## **ADMINISTRATIVE SUBDIVISION PLAN**

M-NCP&PC No. 620240010

13635 Darnestown Road, Darnestown Parcel 606, Rich Meadows

Subject: Questions on Development Plan Number 620240010 - Rich Meadows, Parcel 606

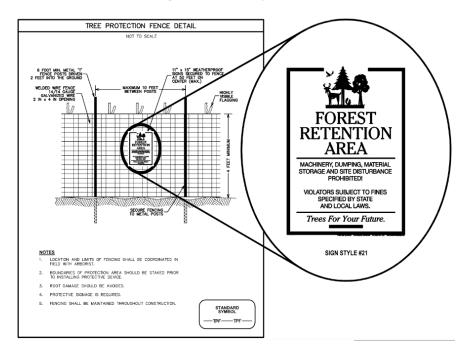
3. Is the tree protection fence temporary? If not, can you describe the style and height?

The tree protection fencing (TPF) is a temporary measure that helps protect existing trees from damage during the construction process. The TPF will be removed once construction is complete. The Forest Conservation Easement signs (above) are permanent.

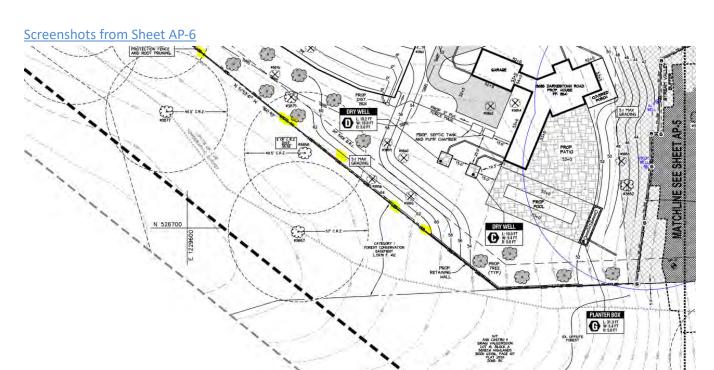
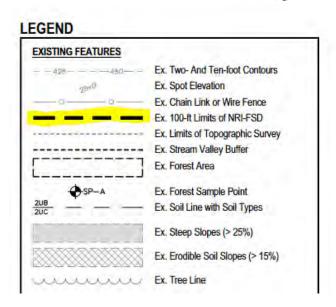
4. What is the purpose of the dashed line labeled **Limits of NRF-FSD Plan**? Since this extends into our lot we expect that there would be zero incursion/disturbance of this area but could you please clarify?

The limits of the NRI-FSD (100 feet from the property line) are distinctly different than the Limits-of-disturbance (LOD) identified in yellow on the plan below. The NRI-FSD limit (highlighted in the legend) is the area they need to look at to identify environmental features, including significant trees, streams, etc. The inventory area does extend outside of the subject property, in order to assess impacts to the off-site trees etc. All land disturbance will occur inside the LOD.
